Text Amendment #2015-0004
Development Site Plan #2015-0005
3601 Jefferson Davis Highway - Target

Application	General Data	
Project Name: Target Expansion	PC Hearing:	June 4, 2015
	CC Hearing:	June 13, 2015
	If approved, DSP Expiration:	June 13, 2018
	Plan Acreage:	2,782,092 sq. ft. (63.86 ac.)
	Site Area:	33,492 sq. ft. (0.77 ac.)
Location: 3601 Jefferson Davis Highway	Zone:	CDD #19 / North Potomac Yard
	Proposed Use:	Retail – Storage
	Dwelling Units:	N/A
	Gross Floor Area:	18,441 sq. ft.
Applicants: Department of Planning and Zoning (Text Amendment) Target represented by, Michelle Rosati, Holland & Knight, LLP (Development Site Plan)	Small Area Plan:	North Potomac Yard
	Historic District:	N/A
	Green Building:	Flexibility from the City’s Green Building Policy

Purpose of Application
A request for approval of an amendment to an existing site plan to construct an addition to the existing Target store in the Potomac Yard Shopping Center.
Applications Requested:
<ol style="list-style-type: none"> 1. Text amendment to amend the provisions of Section 5-602, Table 1, to permit an increase in the maximum square feet of allowable development without a CDD Special Use Permit in CDD #19 / No

Site Plan showing addition at the right

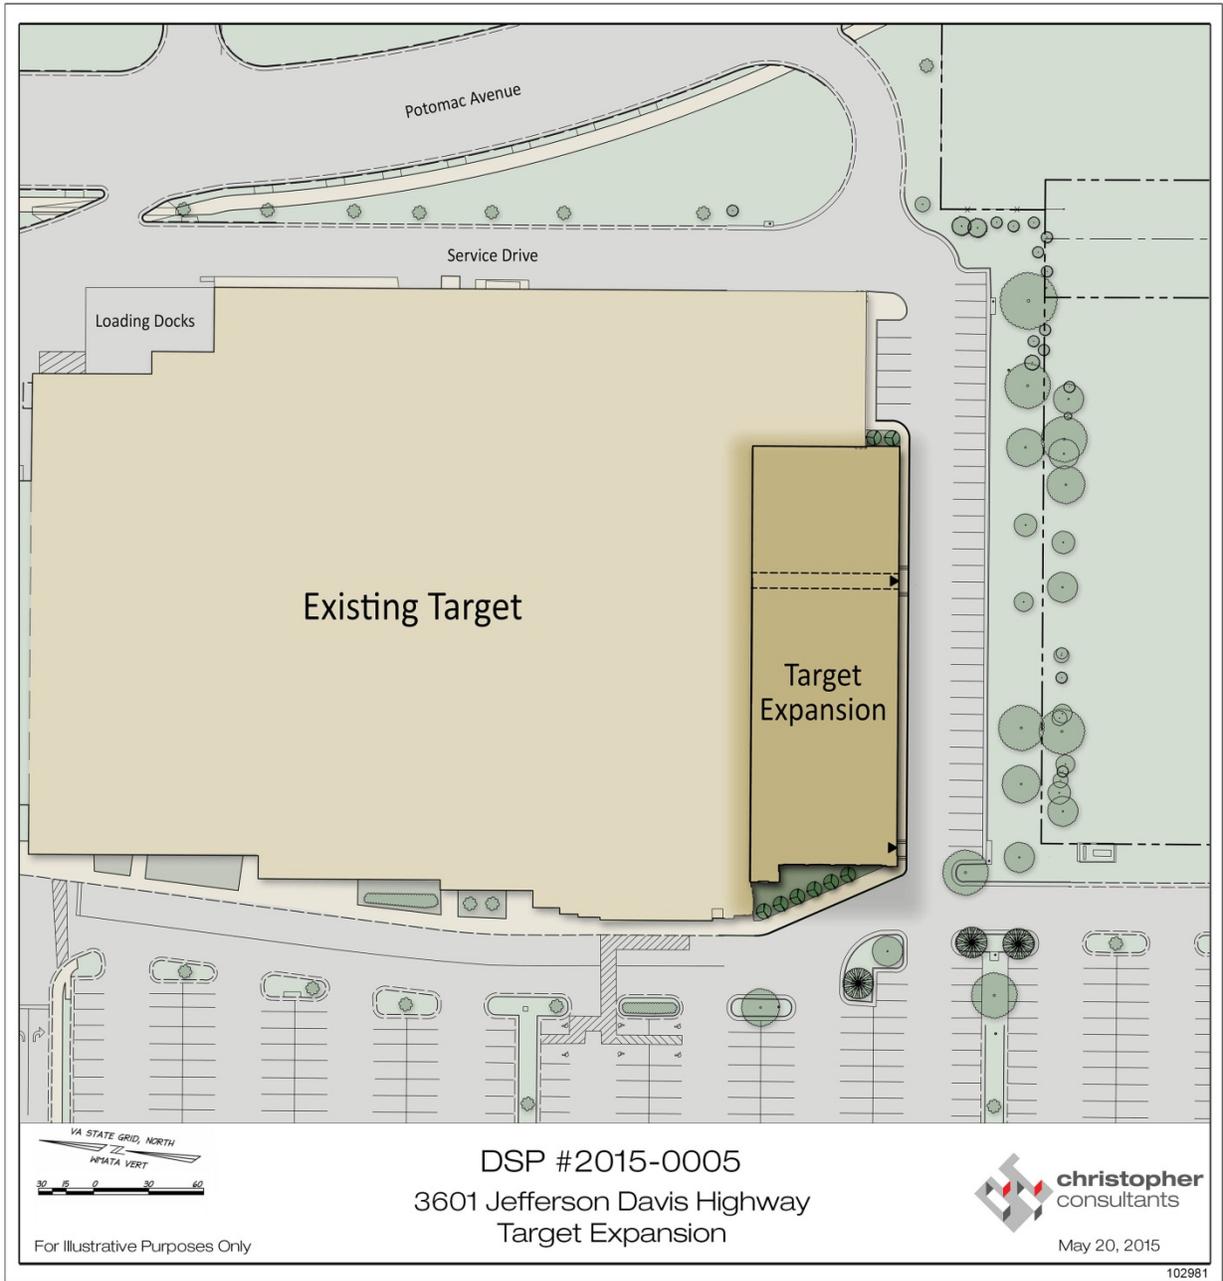
Staff supports the amendment to the existing site plan, and believes that the location, orientation and design of the expansion maintain the intent of the original site design and adequate site access and maneuverability. The addition, which is approximately 80 feet in width, 230 feet in length and 25 feet in height, is designed to appear as a visual extension of the existing store, with corresponding building materials. The addition will be constructed primarily of masonry, including a combination of colored concrete block and brick along the front and south facades. The applicant also proposes brick detailing, including brick piers, to relate to the existing store and provide visual interest along the front and southern façades. The rear façade will be primarily clad in EIFS to match the existing façade treatment. Once completed, the addition will be indistinguishable from the existing store. The applicant also proposes groundcover and ornamental trees along the eastern and western facades, as well as three new shade trees in the parking lot to replace two trees which must be removed to construct the addition.
